## REMARKS

ANNOTATED MARKED-UP DRAWING

**FIG. 1**

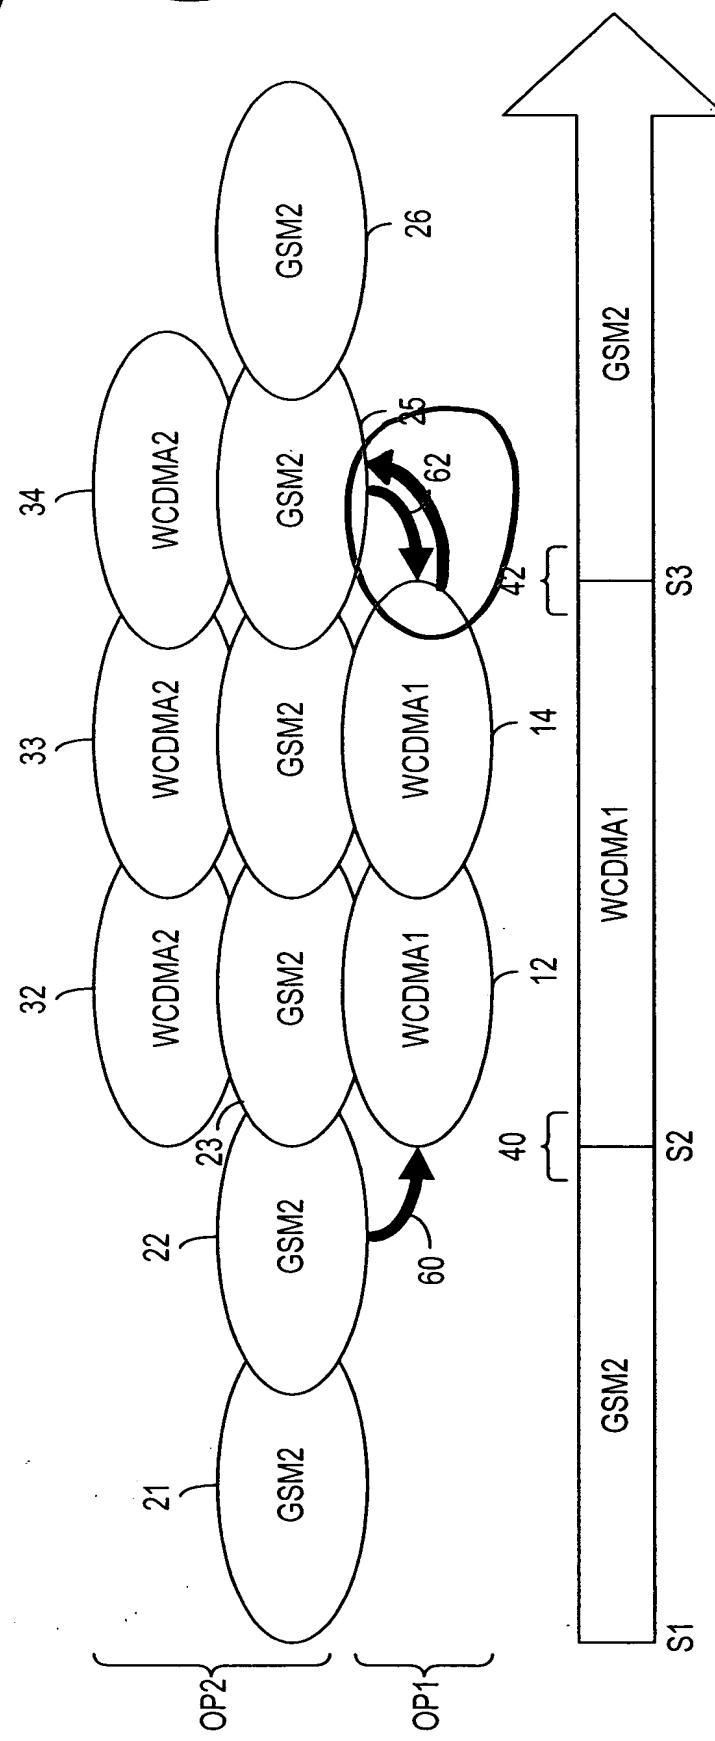
The specification and drawings have been amended to conform with 37 CFR 1.121. In the specification, on page 6, lines 6-7, "Figure 3" has been changed to --Figure 4-- and "step 112" has been changed to --step 116--. In the drawings, the direction of the arrow for handover event 62 has been reversed. No new matter has been introduced by way of amendment.
